Park Redevelopment, Woodquay,
Galway City

Stage 1 & 2 Road Safety Audit

Document Ref:	P24110-PMCE-XX-XX-RP-SA-5_0001
---------------	--------------------------------

3.1.1 Inter-Visibility Restricted by Parking Spaces

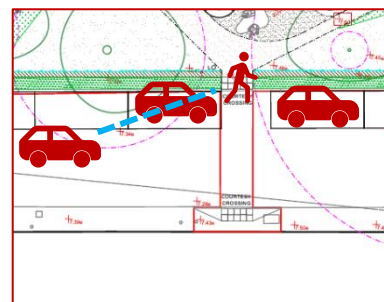
Summary: Inter-visibility between drivers and pedestrians crossing Corrib Terrace from Woodquay Park may be restricted by parked cars on both sides of the crossing.

An uncontrolled pedestrian crossing has been indicated on Corrib Terrace. The pedestrian crossing point exiting Woodquay Park would, however, be located between two parking spaces.

Should one, or both, of these parking spaces be occupied, this may lead to the inter-visibility between approaching drivers and pedestrians waiting at the eastern side of the crossing being restricted. This may lead to a pedestrian entering the carriageway when a driver may not anticipate them to do so resulting in a subsequent risk of vehicle-pedestrian collisions.

The parking spaces should be removed or relocated such that sufficient inter-visibility between a driver, approaching from either direction, and a pedestrian exiting the park at the crossing is provided at this location.

3.1.1	Y	N	Location of crossing point has been moved east to improve visibility. A build-out has been incorporated to improve inter-visibility between drivers and pedestrians	Yes

3.1.2 Inter-visibility Restricted by Hedge Line

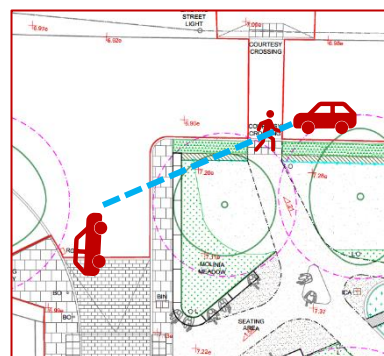
Summary: Inter-visibility between drivers and all road users at the northeastern corner of Woodquay Park may be restricted by hedge planting/fencing.

A row of hedge planting, which would initially be supported by a timber post and rail fence, has been indicated around the border of Woodquay Park. A new uncontrolled pedestrian crossing has also been indicated on Riverside at the northeastern corner of the park.

Information in relation to the intended height of the hedgerow has not been provided and, should it grow too high, this may lead to inter-visibility between drivers approaching this corner from each direction, or southbound drivers and pedestrians waiting at the western side of the crossing being restricted.

This may lead to a southbound driver cutting the corner ahead of an opposing driver turning onto Riverside resulting in a subsequent risk of low-speed head-on collisions, or to a pedestrian entering the carriageway when a driver may not anticipate them to do so and a subsequent risk of vehicle-pedestrian collisions.

The hedgerow planting should be routinely maintained and cut to a height which provides sufficient inter-visibility between all road users at this location.

3.1.2	Y	N	Hedge planting has been removed from this location	Yes
3.1.3	Y	Y	LUC Hard Landscape drawings 12357-LUC-XX-00-DR-L-0106 and 12357-LUC-XX-00-DR-L-0107 provide full details of kerbs

3.1.3 Kerb Heights

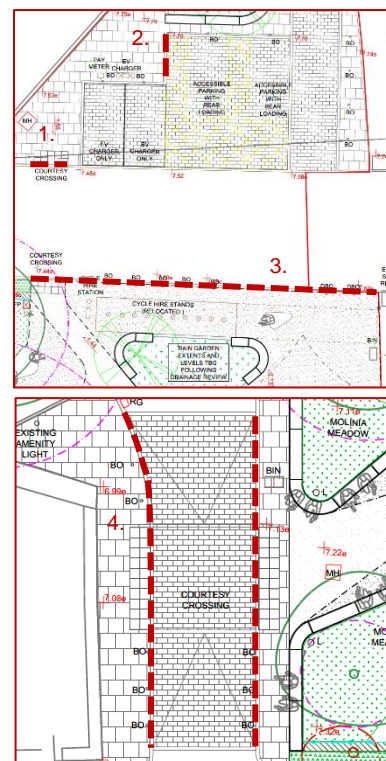
Summary: It is unclear if kerbs of an appropriate height would be provided at all locations within the scheme.

The proposed kerbs within the scheme have been indicated as having a varying height within the legend on the drawing provided and it is, therefore, unclear whether kerbs of an appropriate height would be provided at all locations, including the following:

1. All pedestrian crossings where the provision of kerbs with an upstand greater than 6mm may present trip hazards to pedestrians, or barriers to mobility impaired pedestrians, particularly wheelchair users.

2. Adjacent the mobility-impaired parking spaces at the southeastern corner of the scheme where the absence of a dropped kerb with an appropriate upstand could lead to mobility-impaired vehicle occupants experiencing difficulties entering/exiting their vehicle.

3. At the eastern and western boundary of Woodquay Park at its southern end, where the absence of full height kerbs, outside of pedestrian crossing points, may lead to visually-impaired pedestrians inadvertently entering the carriageway where there is a risk of being struck by a vehicle.

4. At the raised table, indicated at the northern boundary of Woodquay Park, where the provision of flush kerbs outside of the pedestrian crossing may lead to visually-impaired pedestrians inadvertently entering the carriageway where there is a risk of being struck by a vehicle.

Kerbs of a suitable height, appropriate for their location and use, should be provided throughout the scheme.

3.1.4 Layout of Vehicular Access Driveway

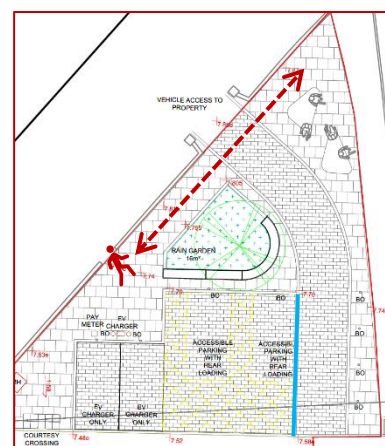
Summary: The layout of the proposed vehicular lane providing access to an existing property is unclear and may result in mobility and visually-impaired pedestrians experiencing difficulties navigating the road layout at this location.

A new access lane has been indicated at the southeastern corner of the scheme to facilitate vehicular access to an existing property at this location. It is, however, unclear if there would be a level difference between the lane and the footpath which bounds it on both sides. Should there be a level difference between these two surfaces, the absence of a pedestrian crossing along the likely pedestrian desire line, adjacent the property boundary line, may lead to mobility and visually-impaired pedestrians experiencing difficulties navigating the road layout.

In addition, should there be a level difference, it is unclear if this kerb would extend across the southern side of the mobility-impaired parking space at this location. Should a kerb be provided across the southern side of the mobility-impaired parking space, this may result in the parking space being of an insufficient size and vehicle occupants may experience difficulties entering/exiting their vehicle from this side.

Alternatively, should there be no level difference between the lane and the surrounding footpath, this may lead to visually-impaired pedestrians inadvertently entering the lane where there is a risk of being struck by a vehicle.

Should there be a level difference between the vehicular access lane and its surrounding footpath, a pedestrian crossing including tactile paving should be provided across the access and a flush kerb provided along the southern side of the mobility-impaired parking space.

Should there be no level difference, suitable measures should be provided to guide visually-impaired pedestrians through this area.

3.1.4	Y	Y	There is no level difference between surfaces. Hazard warning paving has been introduced at location indicated to raise awareness to visually-impaired

3.1.5 Unaccommodated Pedestrian Desire Line

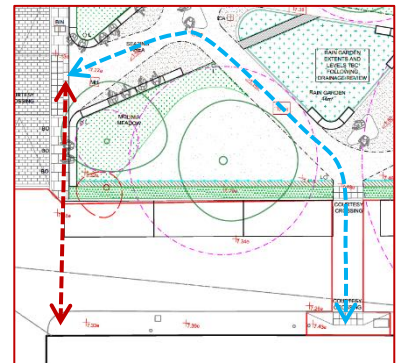
Summary: *The provision of a footpath along the northern boundary of the park without associated pedestrian crossings at both ends may lead to pedestrians crossing Corrib Terrace or Riverside from this footpath where drivers may not anticipate them to do so.*

A new footpath is indicated at the northern boundary of Woodquay Park. No pedestrian crossings have been indicated at either end of the footpath to provide a connection across Corrib Terrace or Riverside, however, this would be the most direct route for pedestrians between these roads, particularly those who wish to travel south on Corrib Terrace. This may, therefore, lead to pedestrians choosing to cross Corrib Terrace or Riverside at the end of the proposed footpath, away from the pedestrian crossings, where drivers may not anticipate them to do so, resulting in an increased risk of vehicle-pedestrian collisions.

The pedestrian routes to the east and west at the park's northern end should be made unattractive to deter their use and thus pedestrians crossing Corrib Terrace or Riverside at these locations. This may be achieved by extending the grassed verges at either end of the footpath northwards across the proposed footpaths, or by an alternative appropriate measure.

3.1.5	Y	Y	Planting has been extended across to block the ends of the routes	
3.1.6	Y	Y	Paths are only intended to be used by pedestrians. All paths widened to 1.2m minimum. Main paths are 2.0m wide.

3.1.6 Width of Internal Paths

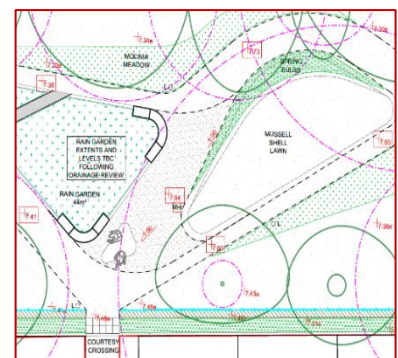
Summary: *The width of the paths within Woodquay Park may not be sufficient to accommodate its intended users.*

A new path network is proposed within Woodquay Park. No information in relation to the width of the paths has been provided, however, sections of the path have been measured as being approximately 1m wide. This width may lead to mobility-impaired pedestrians, particularly wheelchair users, experiencing difficulties when travelling through the park.

In addition, it is unclear if it is intended for the paths to be used by both pedestrians and cyclists. Should the path network be shared by pedestrians and cyclists, narrow paths may result in an increased risk of conflicts between these road users.

If the paths within Woodquay Park are intended to be shared surfaces, they should be a minimum of 2.5m wide. If these are intended to be used only by pedestrians, they should be a minimum of 1.2m wide, but preferably 1.8m wide.

3.1.8 Visibility of Bollards

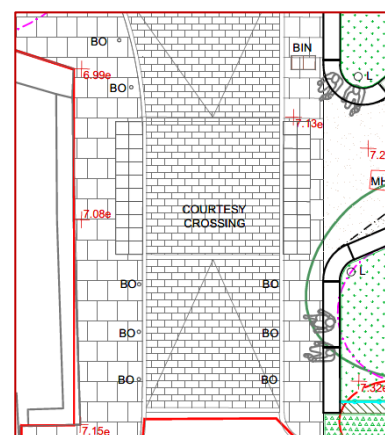
Summary: It is unclear if the proposed bollards would be sufficiently visible during the hours of darkness.

A number of stainless steel bollards have been indicated within the scheme, including on the western side of Riverside and on both sides of the proposed raised table at the park's northwestern boundary. Should the bollards not include reflective measures, there is a risk that they would not be sufficiently visible during the hours of darkness.

In addition, it is unclear if the bollards would be sufficiently setback from the edge of the carriageway.

If the bollards are not sufficiently visible to approaching drivers during the hours of darkness, or should they be located too close to the edge of the carriageway, there is a risk of vehicles striking the bollards and material damage collisions.

The proposed bollards should include reflective measures, such as a reflective band, and be located a minimum of 450mm from the edge of the carriageway.

3.1.7	Y	Y	Tactile paving at all in-line crossings extended to 1.2m depth	
3.1.8	Y	Y	Bollards have been repositioned 450mm away from edge of carriageway and reflective strips included within specification shown on Hard Landscape plans 12357-LUC-XX-00-DR-L-0106 and 12357-LUC-XX-00-DR-L-0107

3.1.9 Absence of Drainage Measures

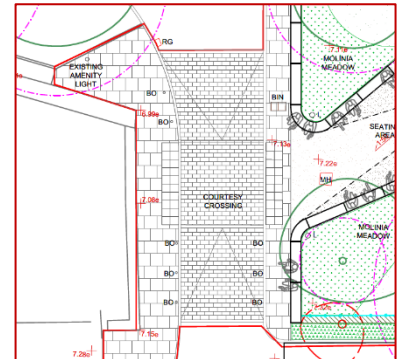
Summary: It is unclear if the carriageway would sufficiently shed surface water at the raised table.

A new raised table has been indicated at the northern boundary of Woodquay Park. There appears to be an existing gully at the northeastern corner of the raised table, however no additional drainage measures appear to be proposed at this location. The existing drainage measures may fail to sufficiently shed surface water which may accumulate at the bottom of the raised table. If the carriageway is not sufficiently drained there is a risk of ponding and loss of traction resulting in the potential for loss of control type incidents, particularly during wet and icy weather conditions.

Sufficient drainage measures should be provided at the raised table such that the carriageway on both sides sufficiently sheds surface water.

3.1.10 Mounting Height of Trees

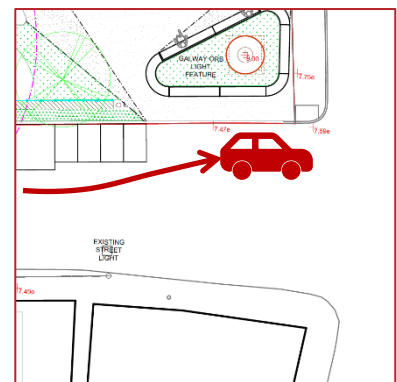
Summary: It is unclear if sufficient vertical clearance would be provided for pedestrians and cyclists beneath tree canopies within the scheme.

Existing trees within Woodquay Park are proposed to be retained at locations where they may overhang the proposed paths and routes that may be shared by pedestrians and cyclists. No information has been provided in relation to the mounting height of these trees and it is, therefore, unclear if sufficient vertical clearance would be provided between the tree canopies and the footpath/shared path. Should trees be mounted too low, tree canopies may present a hazard to pedestrians and cyclists traveling beneath them, resulting in personal injuries if collided with.

Trees which would overhang the footpath, or routes shared by pedestrians and cyclists, should be mounted at a height such that a vertical clearance of 2.3m or 2.5m, respectively, would be provided beneath them.

3.1.11 Location of Motorcycle Parking Spaces

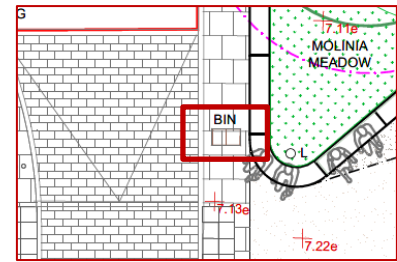
Summary: It is unclear if the swept path of drivers taking up a position at the Stop line on Corrib Terrace would be accommodated due to the location of the motorcycle parking spaces.

A row of motorcycle parking spaces has been indicated on the western side of Corrib Terrace a short distance upstream of its junction with Headford Road. Due to the location of these parking spaces, it is unclear if a driver taking up a position at the Stop line would be able to do so comfortably if these spaces were occupied. Should sufficient space not be available for these drivers, this may result in material damage collisions between vehicles and parked motorcycles.

Confirm, via a swept path analysis, that a driver can safely position themselves at the Stop line when the motorcycle parking spaces are occupied.

To be Completed by Designer				To be Completed by Audit Team Leader
Paragraph No. in Safety Audit Report	Problem Accepted (Yes/No)	Recommended Measure(s) Accepted (Yes/No)	Describe Alternative Measure(s). Give reasons for not accepting recommended measure. Only complete if recommended measure is not accepted	Alternative Measures or Reasons Accepted by Auditors (Yes/No)
3.1.9	Y	Y	Additional gulleys shown on PUNCH drainage drawing 31101-PUNCH-01-XX-DR-C-0101	
3.1.10	Y	Y	No cycle access is proposed within the park.	
3.1.11	Y	Y	Refer to PUNCH swept path drawings 231101-PUNCH-01-XX-DR-C-0601, 0602, 0603. Parking spaces have been adjusted to ensure no clash with swept path of drivers taking up a position at the Stop line

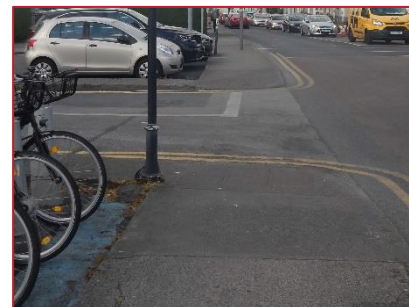
- 4.1 A bin has been indicated in a central position within the proposed footpath at the northern boundary of Woodquay Park immediately to the east of the raised table pedestrian crossing. The bin may obstruct the path of pedestrians travelling within the footpath and it should, therefore, be relocated.

- 4.2 It was noted during the site visit that the tactile paving layout at the existing signalised crossing on Headford Road, to the east of its junction with Riverside, is incorrect. This may lead to visually-impaired pedestrians misinterpreting the type of pedestrian crossing and impacting their ability to navigate the road layout. Should it fall within the scope of the scheme, the tactile paving layout on both sides of this crossing should be updated to be 'L-shaped,' and red in colour, with the stem of the tactile paving located on the right-hand side and extending to the back of the footpath.
